Technical Bulletin T773

Product: A/V Receiver

Hardware Technical Bulletin: T773-H2005-05

Date: February 28/05 **Subject:** Intermittantly shuts down
Note: Implemented in production from serial number:R44T77301971

Figure 1

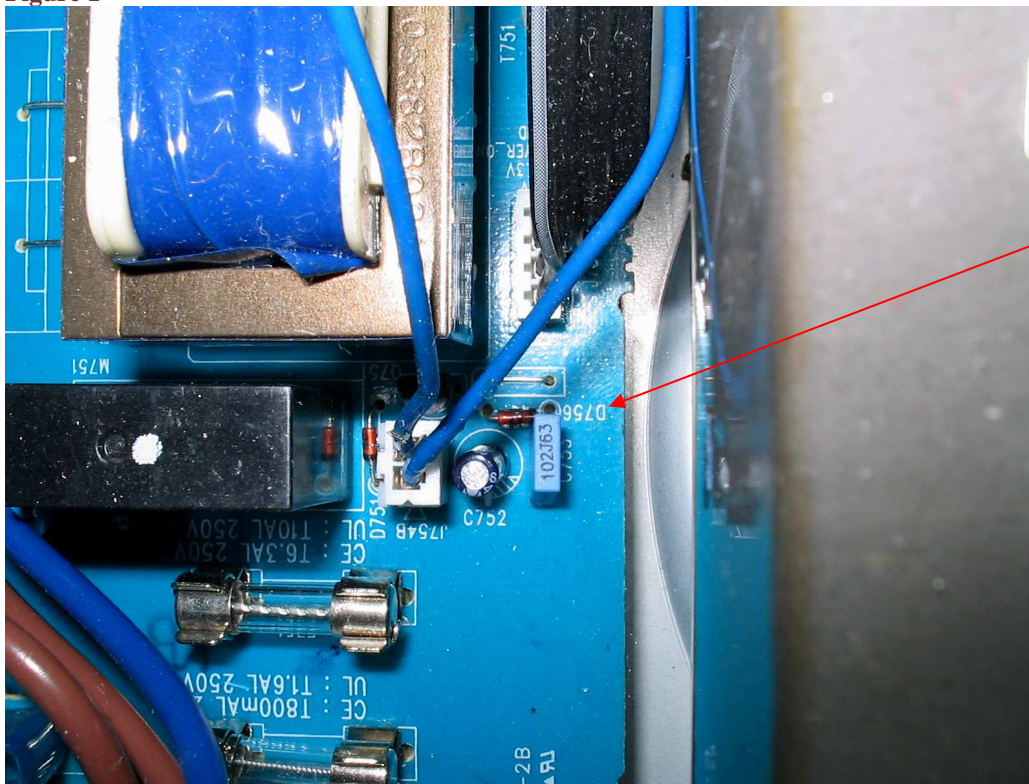
DESCRIPTION: Unit may shut down, shortly after turn on.

REASON: There is a diode on the standby board that maybe operating intermittantly.

SOLUTION: Locate and identify D756 on the standby board. Change only if the diode is a 1N4148. Change from a 1N4148 to a 1N4004 or equivalent. See figure 1 for details.

D756
CHANGE
FROM
1N4148 TO
1N4004
